WLTP

Comparison of WLTP unified database distributions and WLTC rev2 distributions

Heinz Steven

08.10.2011

Figure 8

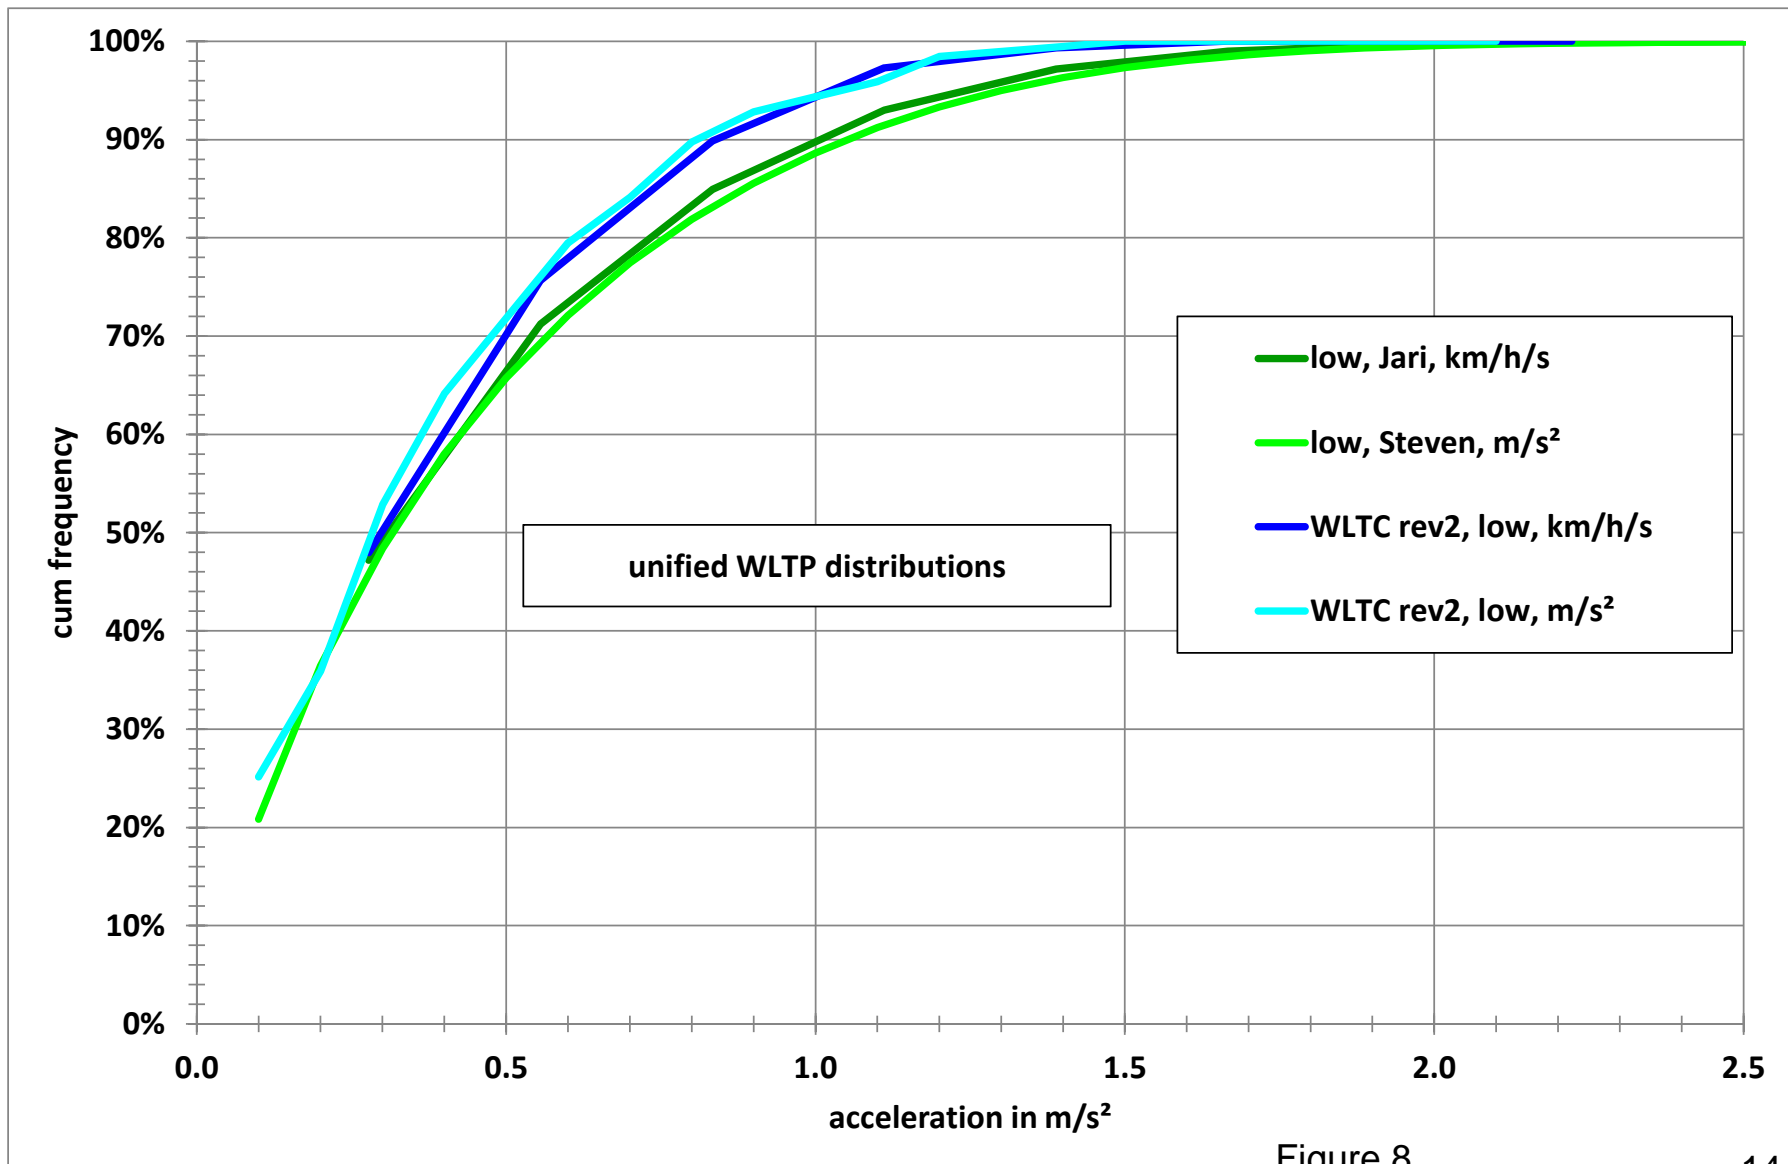
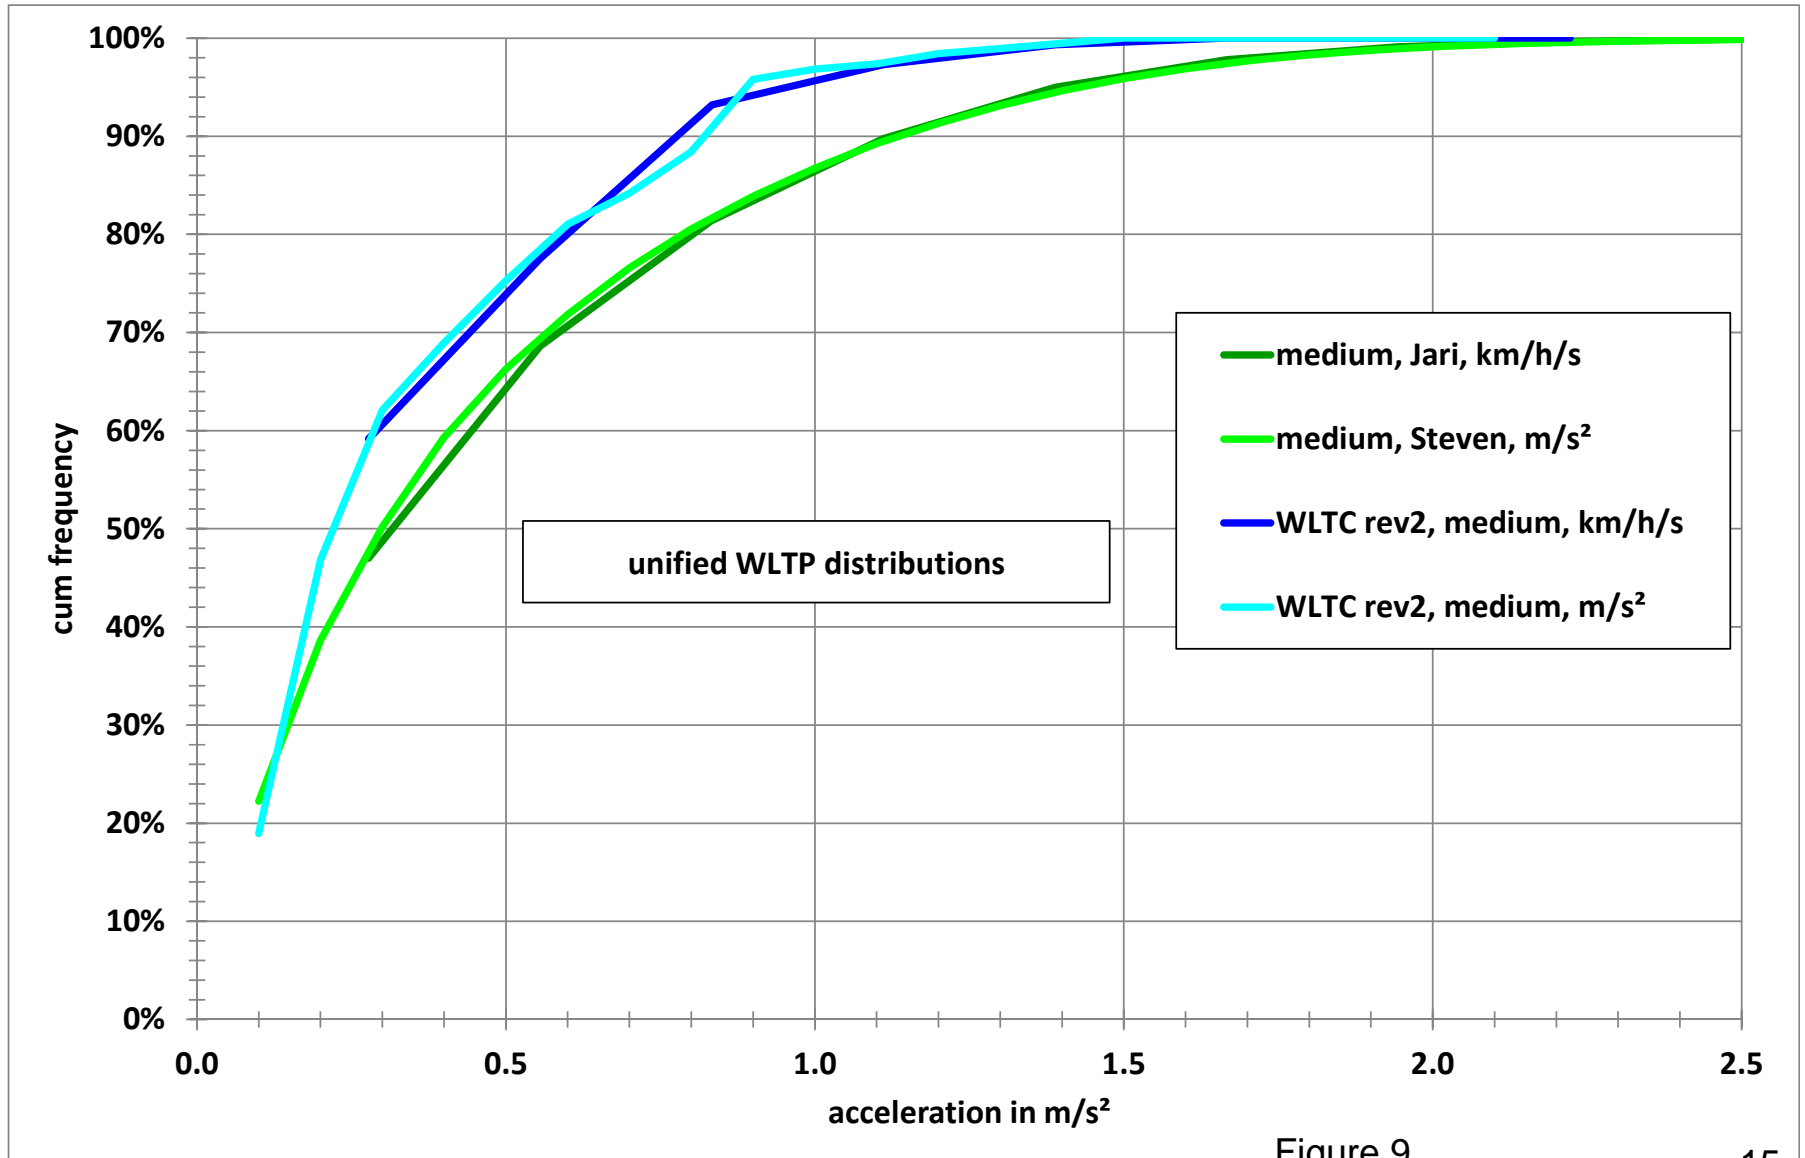
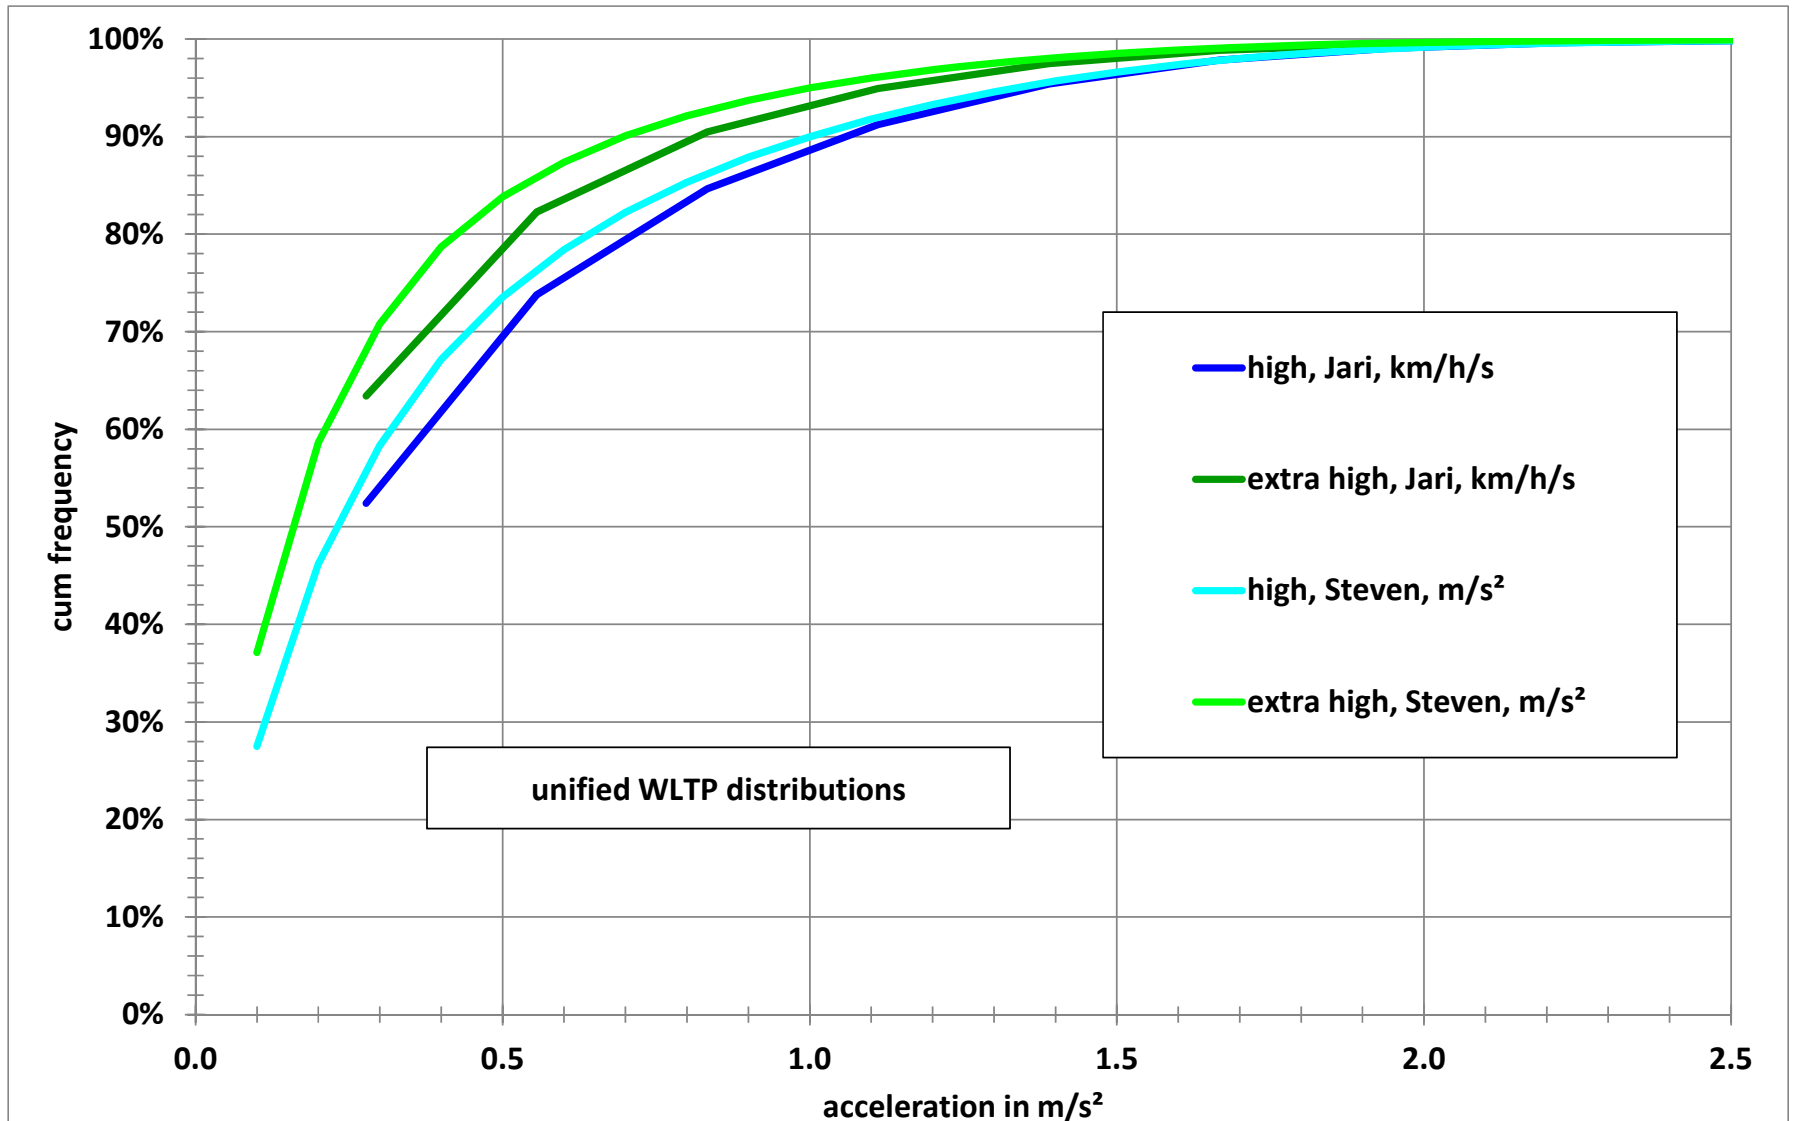
- **The development approach should be related to the positive acceleration section instead.**
- **When focussing on this section the lower dynamics of the WLTC rev2 in comparison to the database distributions for low and medium speeds becomes more obvious (see figures 8 and 9).**
- **But the different acceleration classification systems used by JARI and JRC/Steven become important within this context, especially for the high and extra high speed parts (see figure 10).**
